August 7, 2015

Subject: Southwestern Parkway Storage Basin

Minor Project Modification

IOAP Project No. L_OR_MF_105_M_13_B_A_0

CSO Project Fact Sheet 2012 IOAP Project Modification

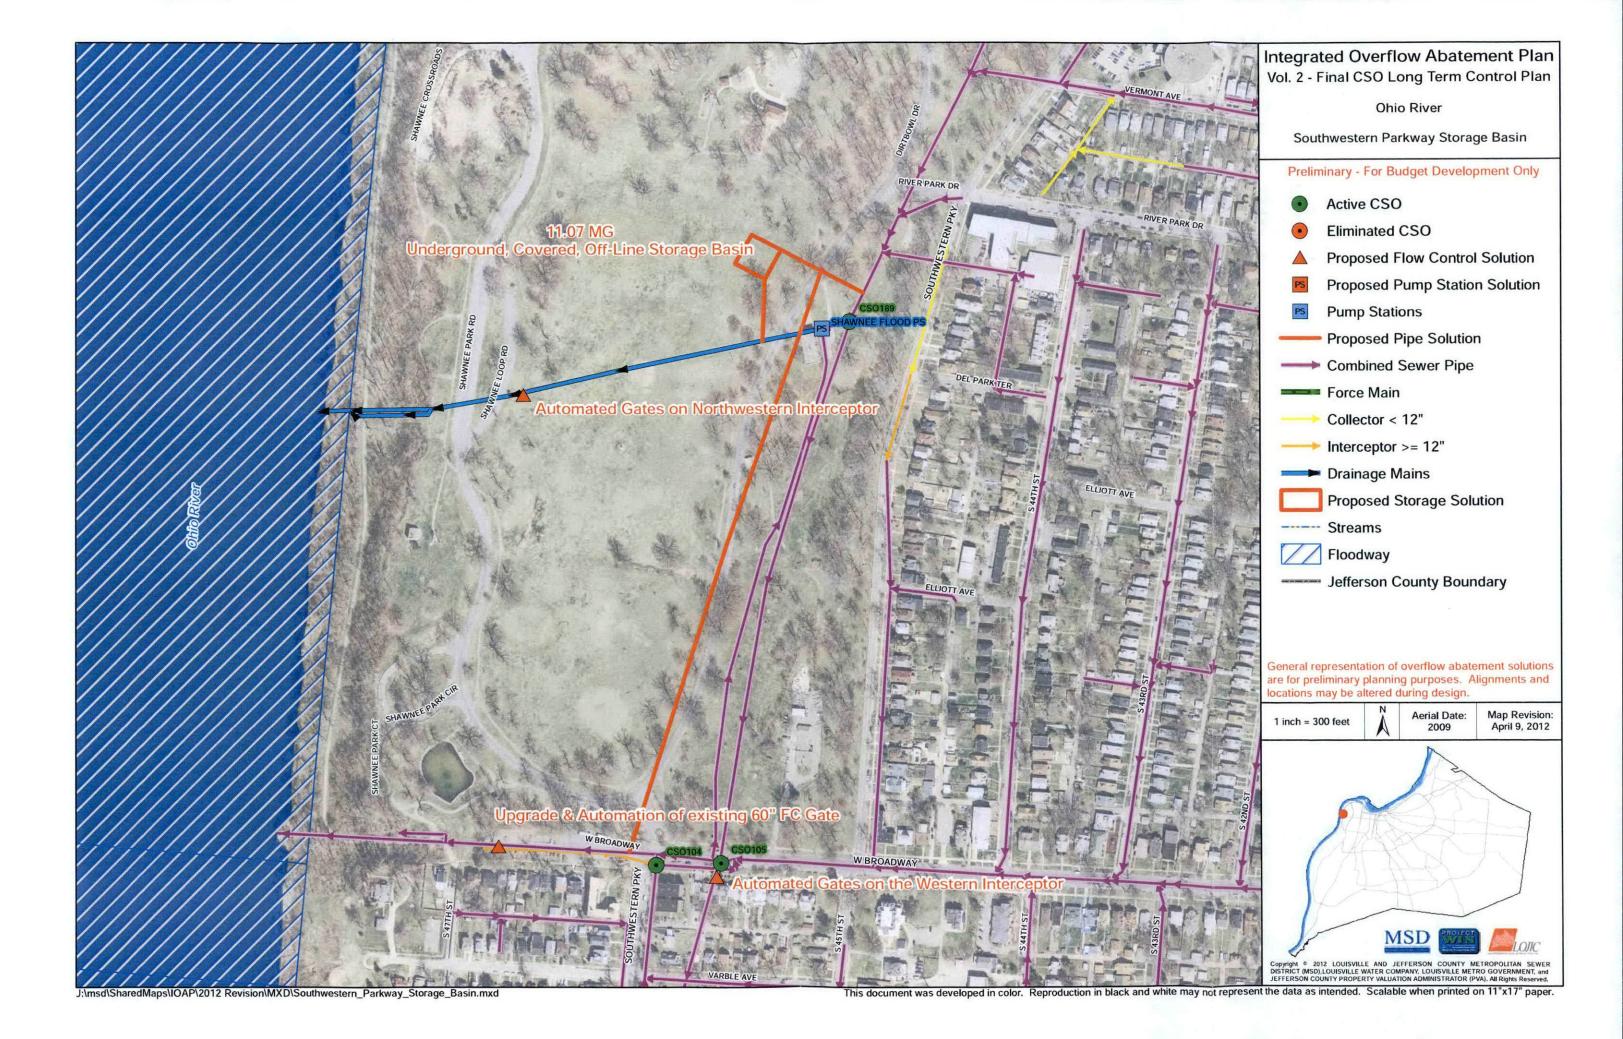
This project modification request includes increasing the Southwestern Parkway Storage Basin size from 11.07 MG to 20.0 MG. This basin size assumes the continued use of in-line storage in the Western Outfall and the Northwest Interceptor, and a proactive approach to green infrastructure in the sewershed aimed at reducing impervious area by at least 2% by the end of the year 2020. The level of control is proposed to change from 0 overflows per year in the typical year to 8 overflows per year in the typical year based on a revised level of control analysis performed in accordance with the procedures established as part of the 2009 approved IOAP. No change in project completion date is proposed.

This project includes a 11.07 MG underground covered concrete basin for CSO104, 105, and 189 and in-line storage in the Western Outfall and the Northwest Interceptor for an an additional 8.8 MG using adjustable gates

Project Description: This project includes a 20 MG underground covered concrete basin for CSO104, 105, and 189 and in-line storage

in the Western Outfall and the Northwest Interceptor for an additional 8.8 MG using adjustable gates to reduce

overflows to eight overflows per typical year.
